Department of Lands and Natural Resources

**Comments on the Draft Commonwealth of the
Northern Mariana Islands Joint Military
Training Environmental Impact Statement/
Overseas Environmental Impact Statement**

September 2015

Figure 2. Map of Saipan and Tinian 3 geographical mile submerged lands limits, showing difference between geographical and statute miles, and overlap of Saipan and Tinian submerged lands

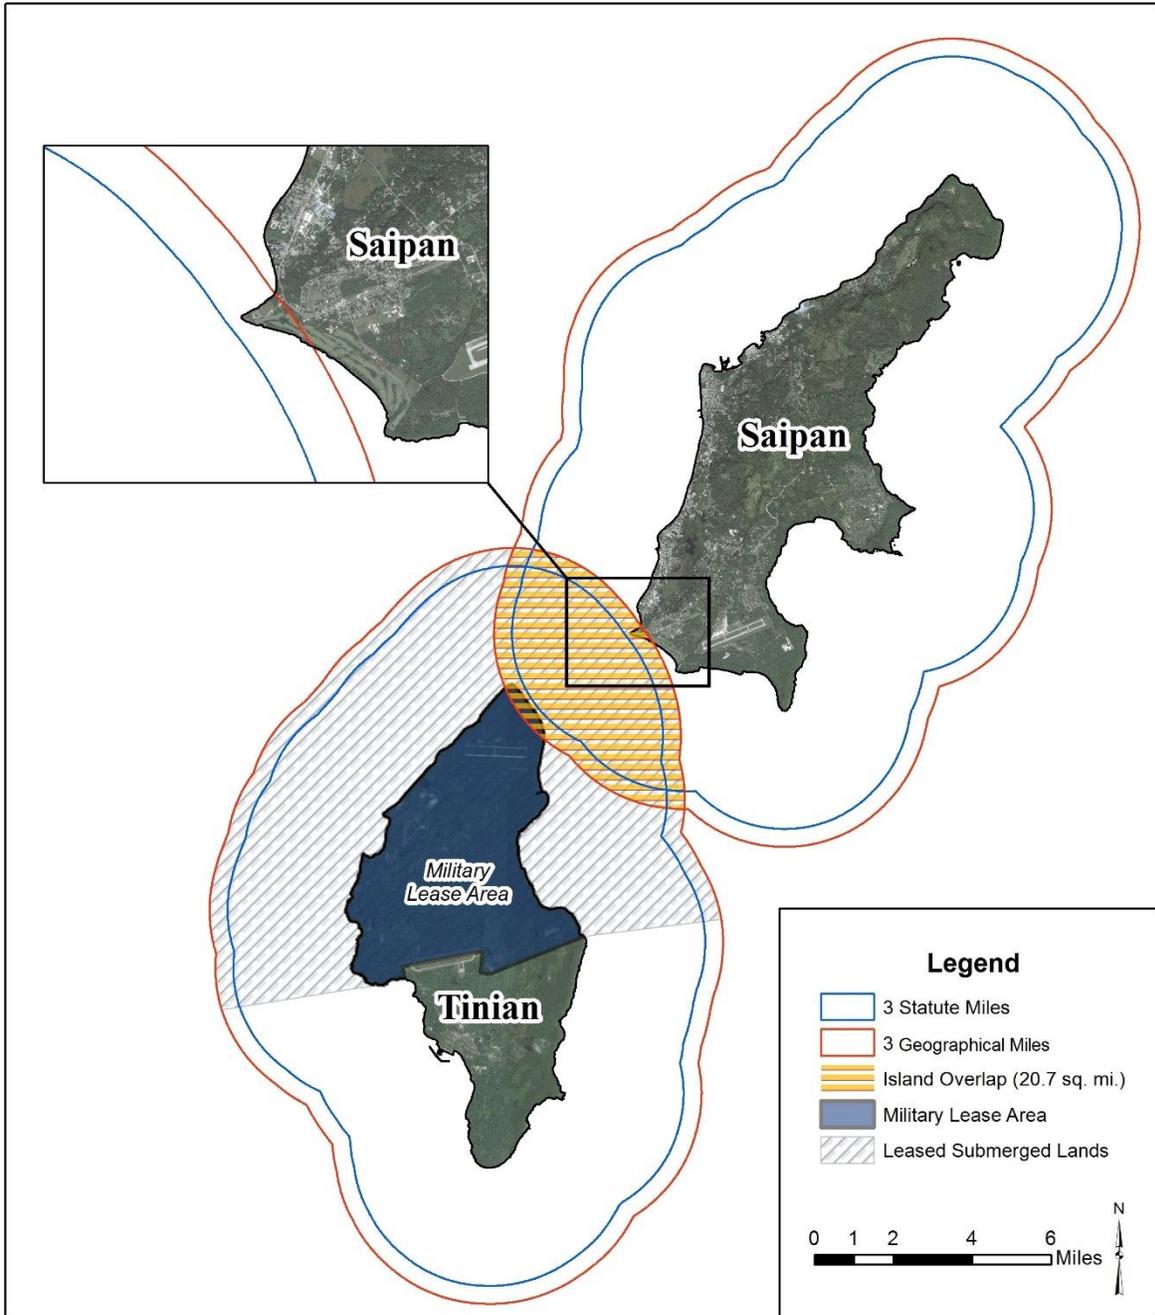
Three geographical miles of submerged lands off the coast of Tinian overlap with three geographical miles of submerged lands off the coast of Saipan. There are 20.7 square miles within the Tinian–Saipan 3-geographical mile submerged lands overlap. The 20.7 square mile area of Tinian and Saipan’s 3-geographical mile submerged lands is shown in orange in Figure 2 of the current document. Presidential Proclamation 9077 did not address the issue of overlap when the Tinian MLA submerged lands were excluded from the conveyance. The ownership of the Saipan and Tinian overlapping submerged lands has not been resolved.

The 3-geographical mile limit is shown in blue on Figure 2 of the current document. The 3-statute mile limit is shown for comparative purposes. It appears that the DoD has depicted statute miles, not geographical miles, in Figure 3.7-1, even though the DEIS references 3 nautical miles for the definition of submerged lands throughout the document. In addition, both the Presidential Proclamation 9077 and 48 U.S. Code § 1705(a) refer to geographical miles (1,855 meters) in their definitions of CNMI submerged lands, not nautical miles (1,852 meters). This would make significant difference to the area of the Tinian and Saipan submerged lands overlap and in the boundary of the submerged lands of both islands.
